# UNITED STATES PATENT AND TRADEMARK OFFICE

APPLICATION NO.	FILING DATE	FIRST NAMED INVENTOR	ATTORNEY DOCKET NO.	CONFIRMATION NO.
10/643,247	08/15/2003	Etienne Douw Visser	JG0737US (#90578)	3591

## Office Action Summary

## **DETAILED ACTION**

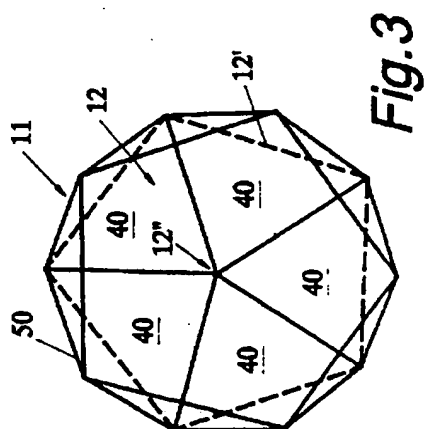
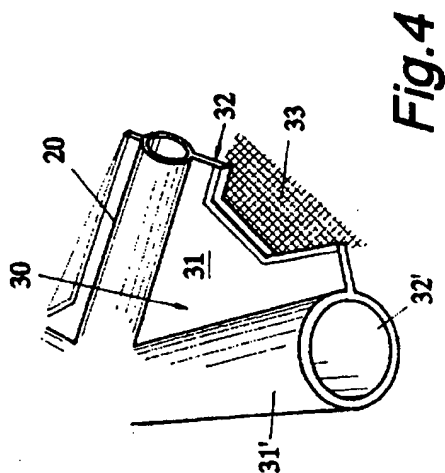
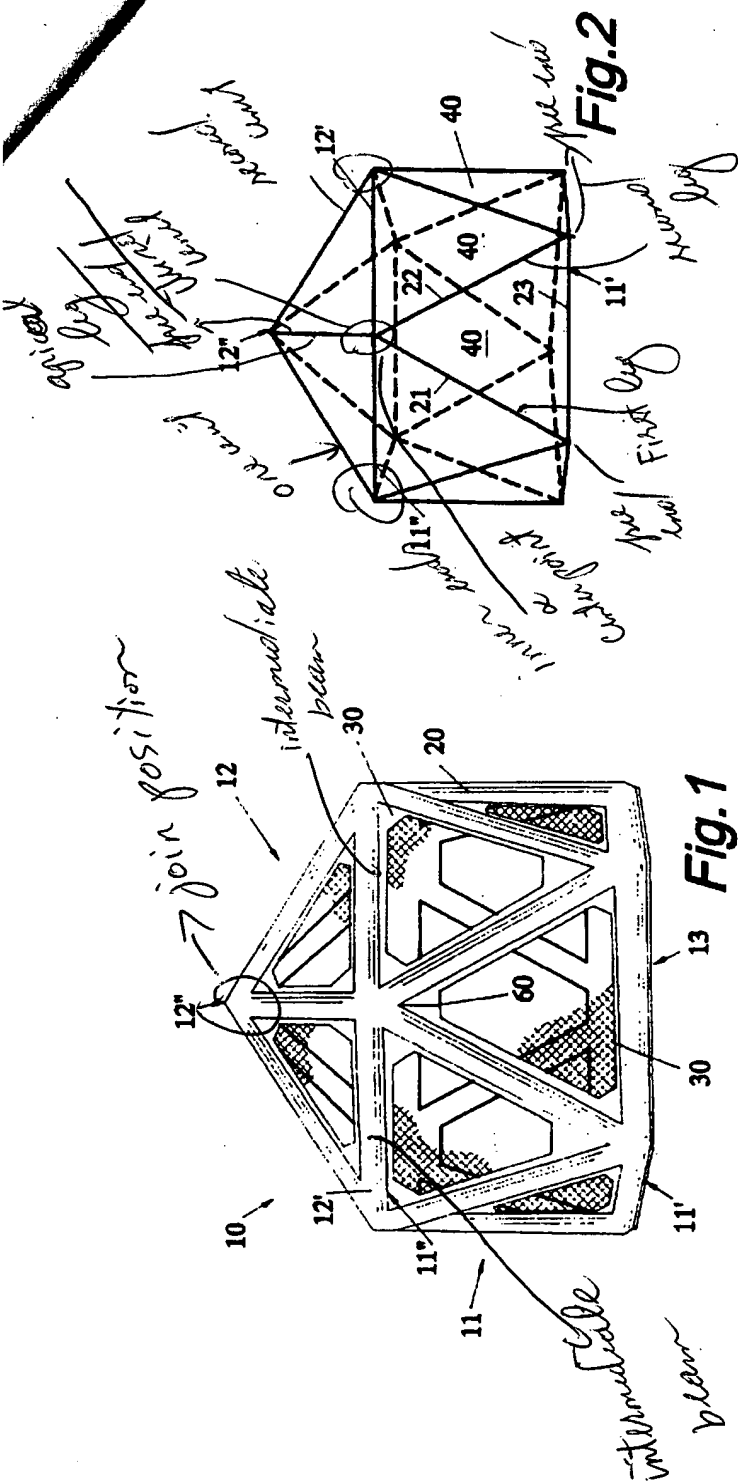
Ryan et al (see attached) shows a structure comprising at least three structural units, each of said at least three units consisting of three inflatable legs (21, 22, and the apical leg) constituting two support legs and an apical leg, each leg having a free end and an inner end (see attached), the inner ends of the three legs being joined at a center point, the legs being arranged in more than one plane to define a tetrahedron with the three legs lying on three adjacent edges of the tetrahedron and with adjacent pairs of legs lying in planes of three sides of the tetrahedron, the free ends of the legs defining the fourth side of the tetrahedron, the apical legs of the units are joined to corresponding legs of the other units at a join position (see attached), the three legs of each unit are of the same length (figure 7), the legs are straight, a connector unit (13) is provided at the free end of at least one of the legs of each element, the apical legs are all joined directly together (at 12''), some of the apical legs being connected to other legs (not an apical leg) through an intermediate beam (see attached), the outer ends of the legs are shaped complementary to permit interconnection of the structural elements along the axial angle of the completed structure (inherently so as the apical leg connected to each other and are thus complementary).

Fig. 3

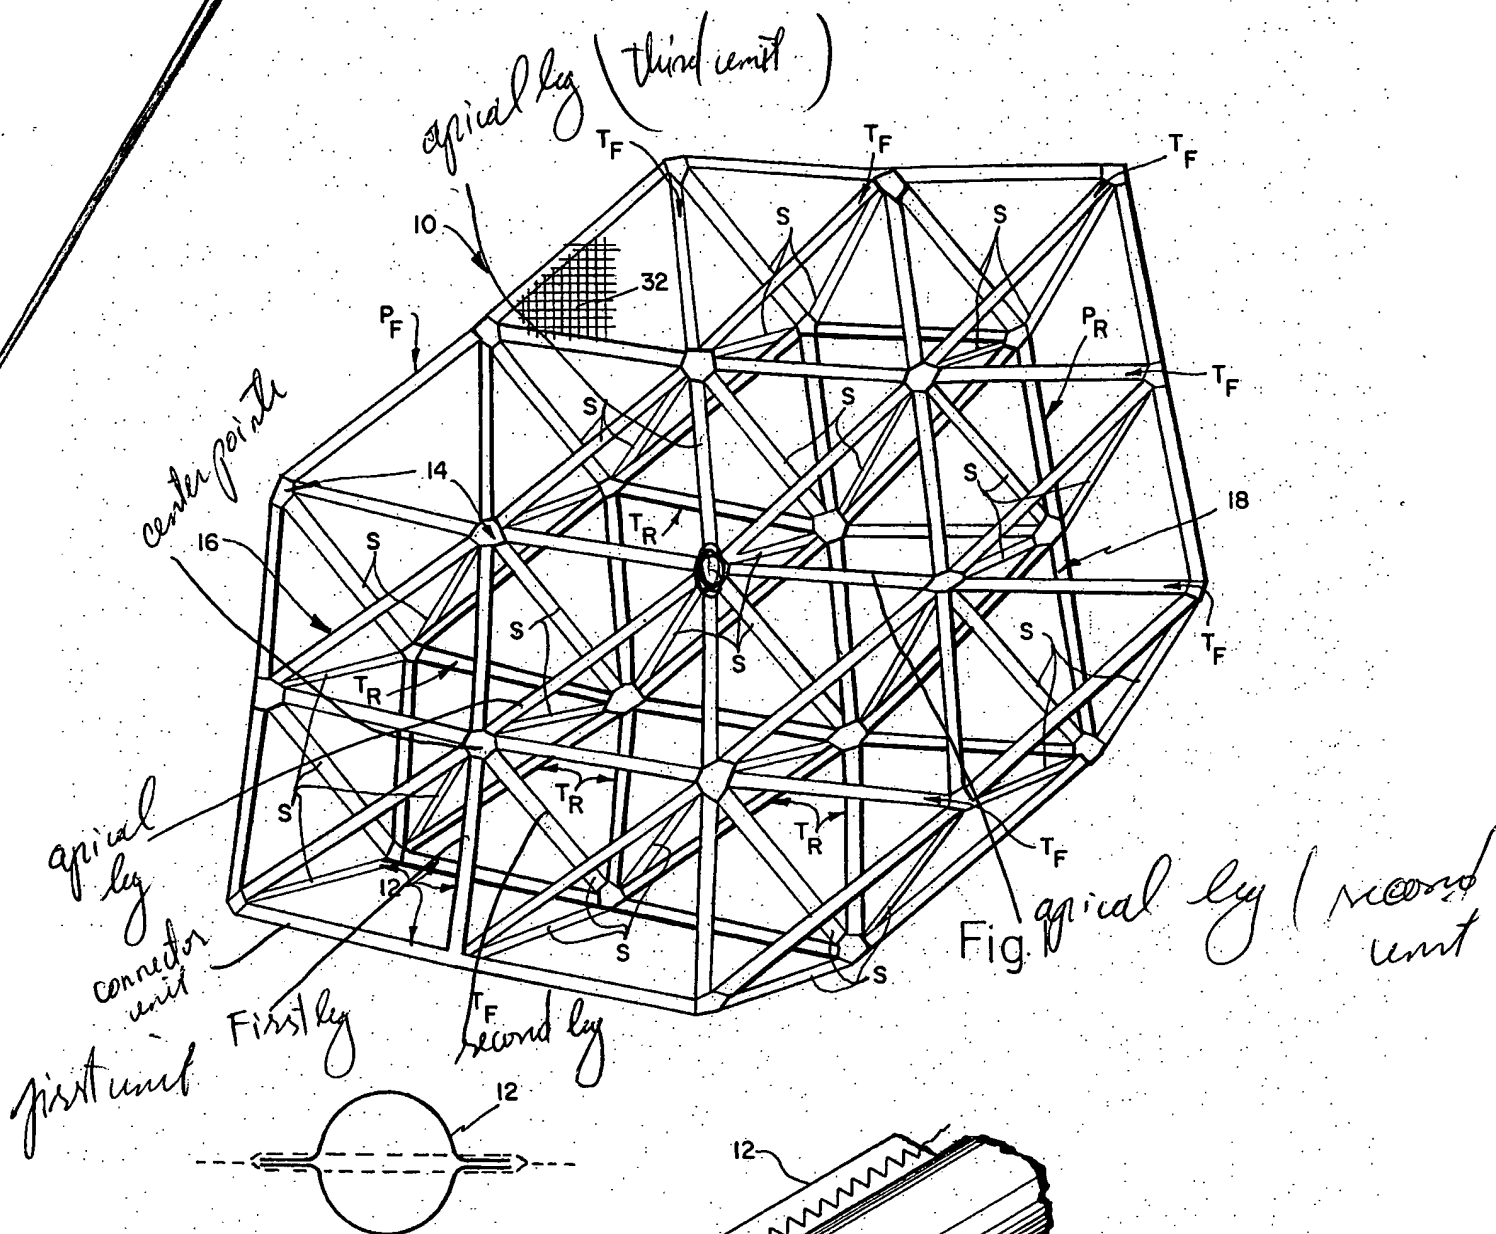
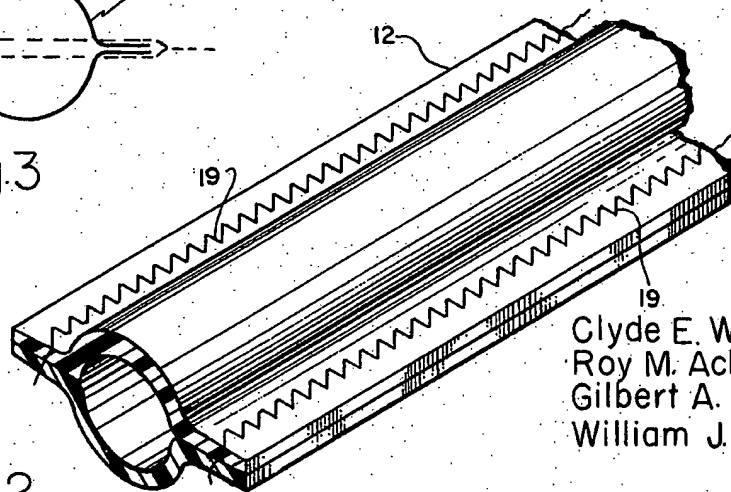
Williamson et al (see attached) shows a structure comprising at least three structural units, each of said at least three units consisting of three inflatable legs (see attached) constituting two support legs and an apical leg, each leg having a free end and an inner end, the inner ends of the three legs being joined at a center point, the legs being arranged in more than one plane to define a tetrahedron with the three legs lying on three adjacent edges of the tetrahedron and with

adjacent pairs of legs lying in planes of three sides of the tetrahedron, the free ends of the legs defining the fourth side of the tetrahedron, the apical legs of the units are joined to corresponding legs of the other units at a join position (see attached), two of the legs of the same length and the third leg being of a different length (second leg and apical leg being same length, the first leg is shorter), each leg is straight, a connector unit is provided at the free end of at least one of the legs of each element, the apical legs are all joined directly together (see attached), the outer ends of the legs are shaped complementary to permit interconnection of the structural elements along the axial angle of the completed structure (inherently so as the apical leg connected to each other and are thus complementary).
